Appl. No. 10/662,073  
Amdt. dated June 16, 2006  
Reply to Office Action of March 16, 2006

**Amendments to the Drawings:**

**FIG. 7**

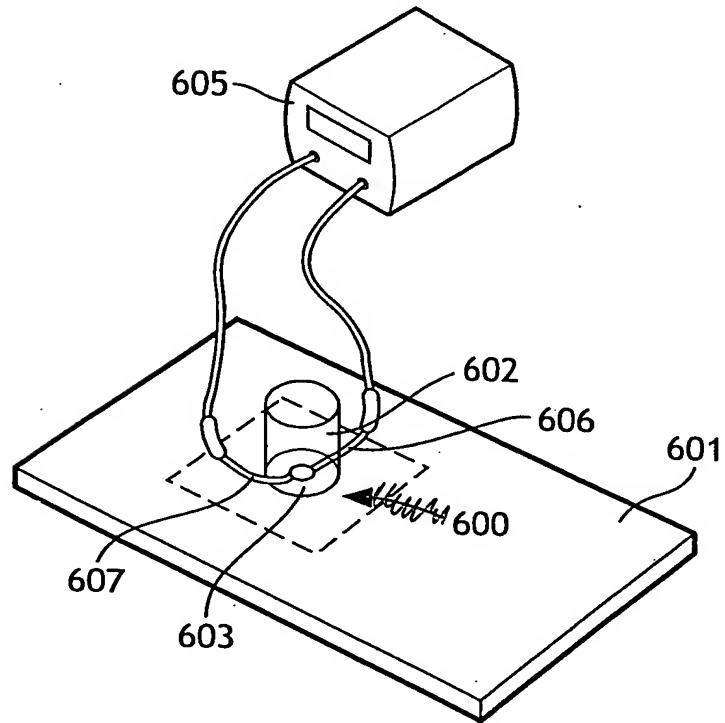
By way of the Office Action mailed March 16, 2006, the Examiner has objected to the drawings because Figure 7 should be dashed to denote underlying structure. A replacement sheet of drawings including changes to Figure 7 and original Figure 8 has been provided. Applicants believe that this amendment overcomes the objection. Applicants respectfully request that this objection be withdrawn.

The attached sheets of drawings includes changes to Figure 7 and the addition of Figure 9 and Figure 10. The first sheet, which includes Figure 7 and Figure 8 replaces the original sheets including Figure 7 and Figure 8. The second sheet is an annotated sheet including Figure 7 and Figure 8 showing changes to Figure 7. The third sheet is a new drawing sheet which includes Figure 9 and Figure 10.
